June 13, 2022

Re: RWR127 Swinney - Ceiling Field Change

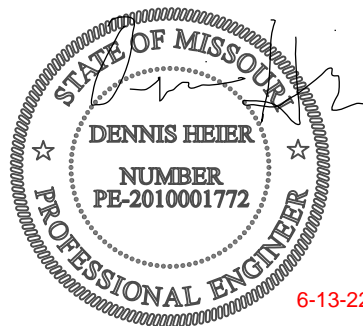
Per conversation with Jeffrey Pfeifer, on June 13, 2022, Vista Structural Engineering, LLC was asked to omit the triple 2x10 and rotate the ceiling joist span in the Master W-I.

This change is acceptable. Please see the following partial plan mark up of the main fl ceiling for reference.
